Project: 226052 DFCI-BIDMC New Cancer Hospital - 1 Joslin Place - Construction
1 Joslin Place
Boston, Massachusetts 02215

RFI #0-PB-95: LBE Alternate - A,B/6 and A,B.1/4.1

S1.P4M

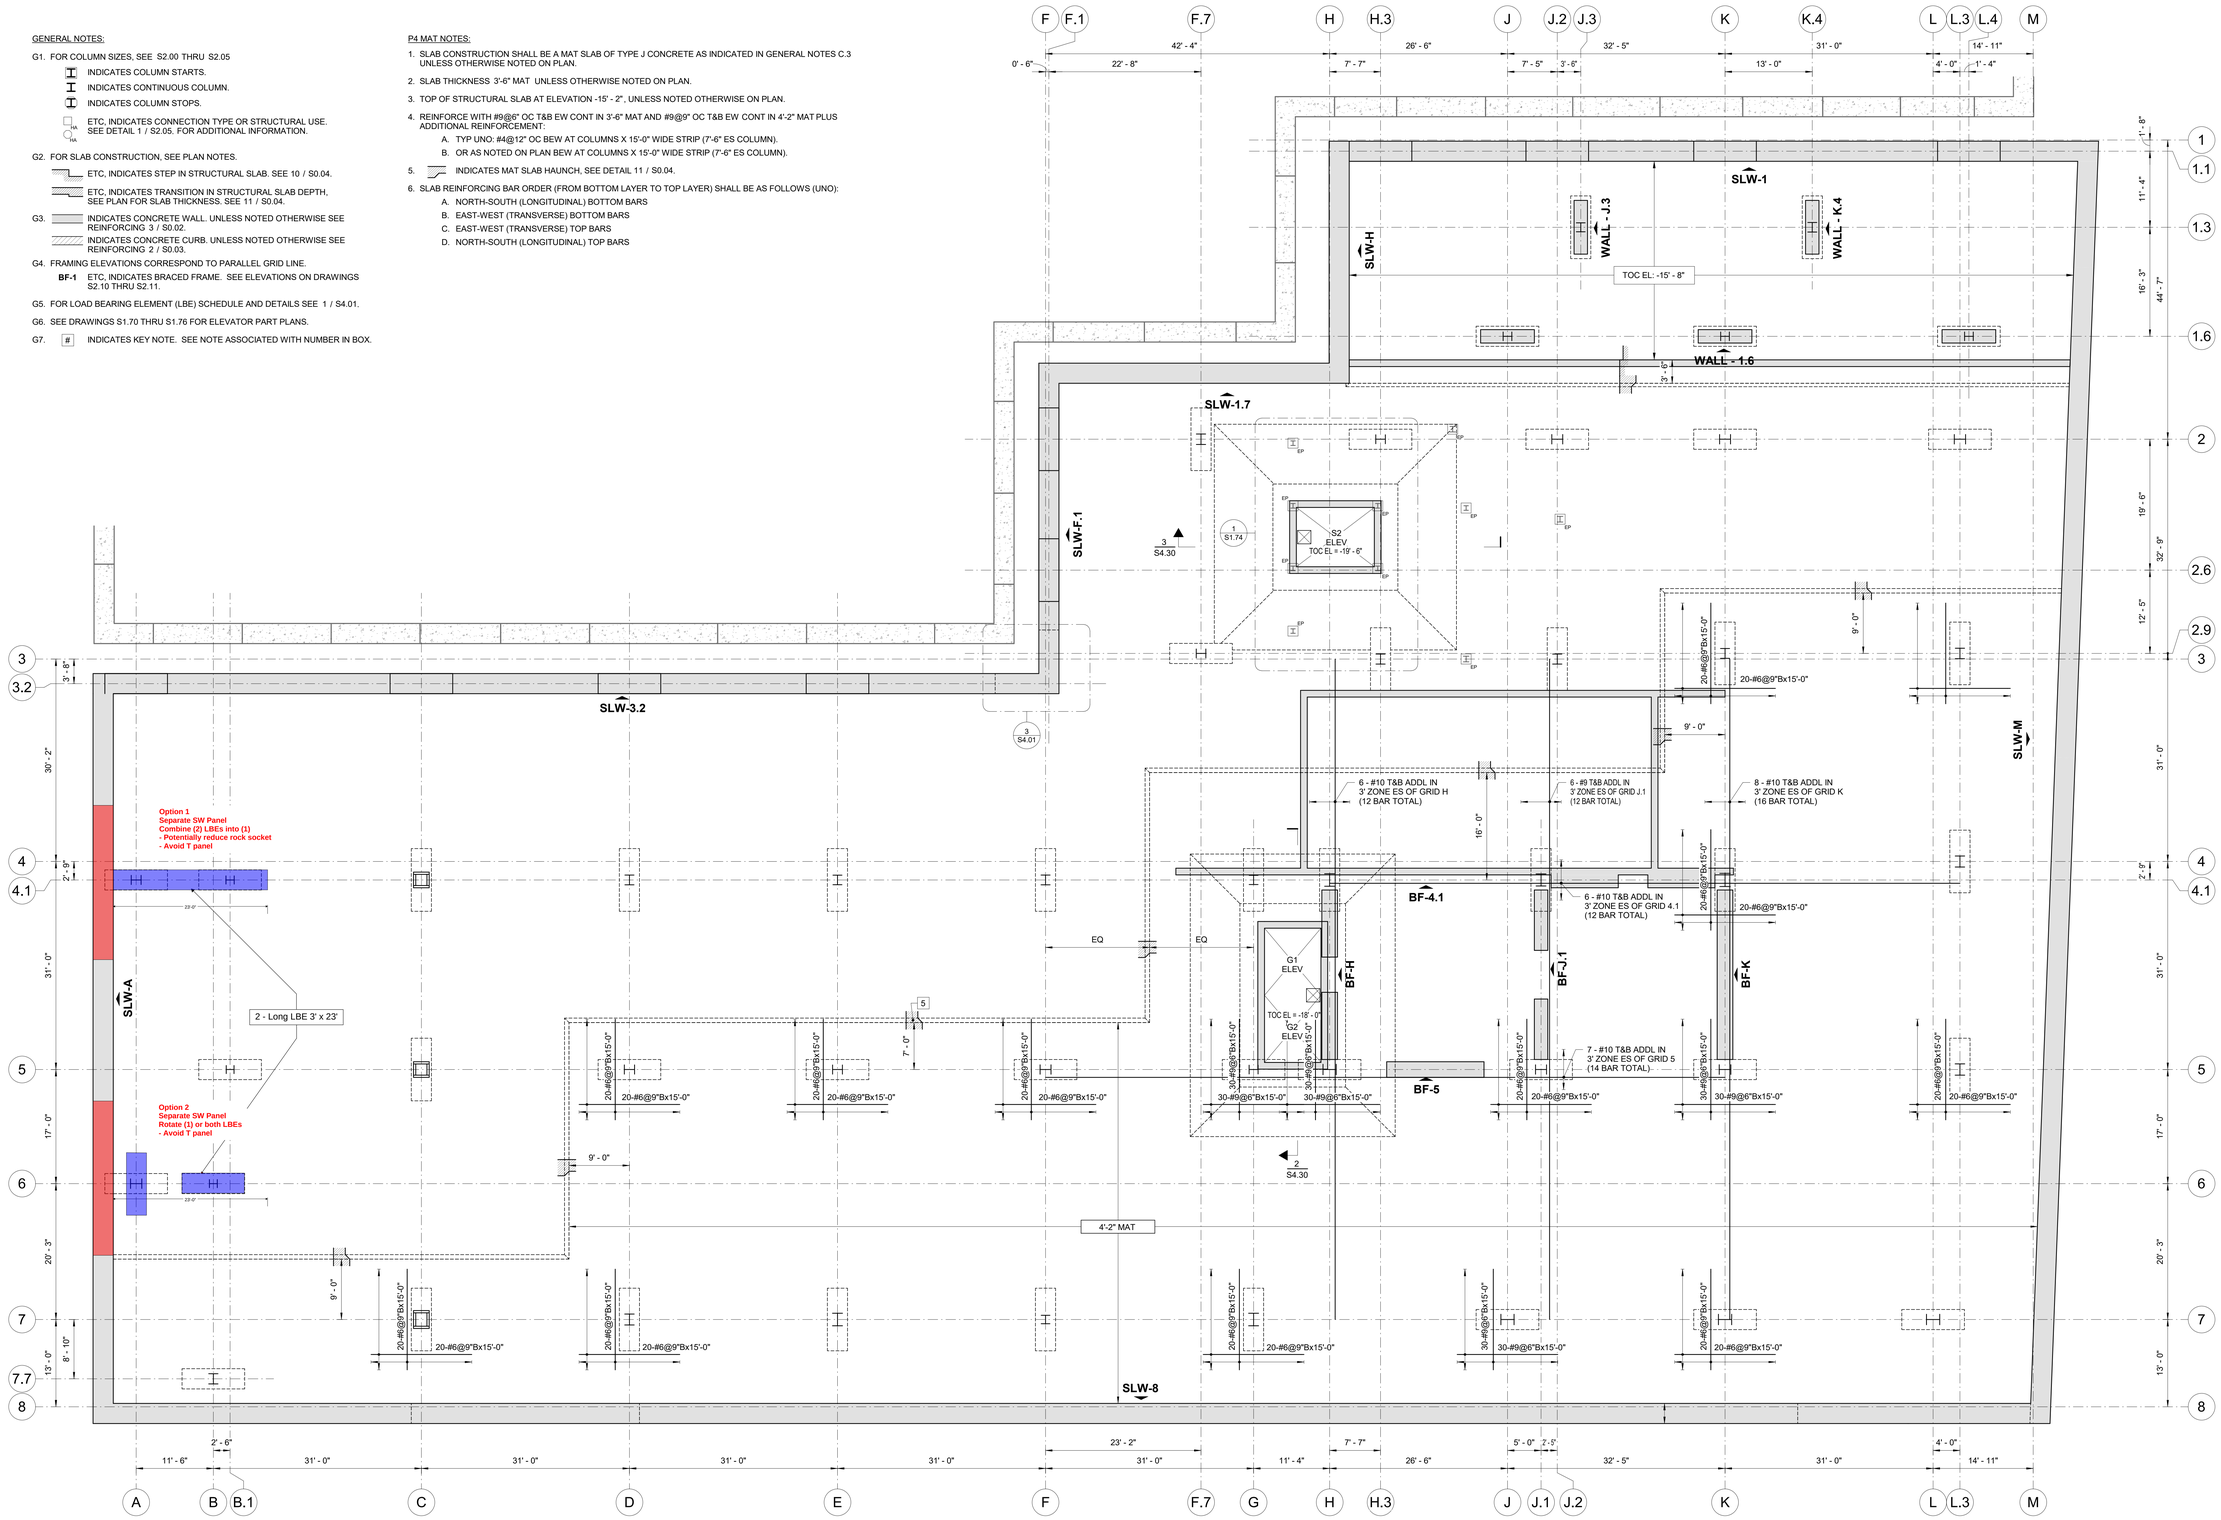
Please reference attached for proposed alternate for LBEs located on A,B/6 line and A,B.1/4.1 line.

1. Option 1 - Separate SW panel and combine (2) LBEs into 1
    1. Potentially reduces rock socket
    2. Avoids T Panel
2. Option 2 - Separate SW panel and rotate (1) or both LBEs
    1. Avoids T Panel

Please advise if these proposed alternatives are acceptable.

Per Payette 12/2/2025 response: Contractor proposed alternates will be reviewed in further depth and incorporated into 1/15 Addendum if permissible. Suffolk shall coordinate with all subcontractors who previously proposed scope as shown on documents.
